8. <u>Revisions proposed to Recommendation 0.162</u>

TABLE 2/0.162

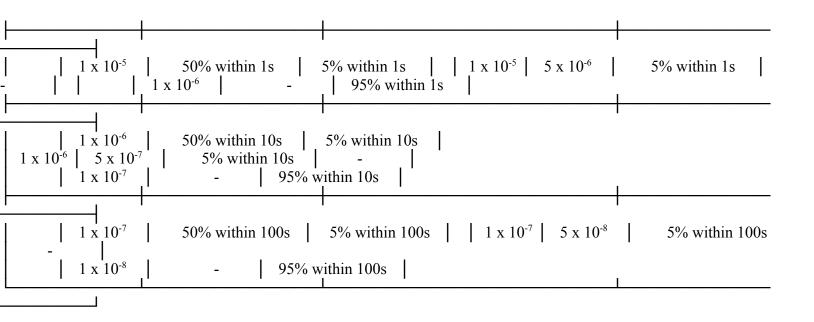
3.4.3 The instrument shall have a means of indicating binary error ratios of 1×10^{-5} , 1×10^{-6} and 1×10^{-7} and shall cause the appropriate indicator to be illuminated under the conditions defined.

The indication of binary error ratios occurring in the received decoded signal and detected by means of the CRC procedure information shall comply with the limits given in Table 2/0.162.
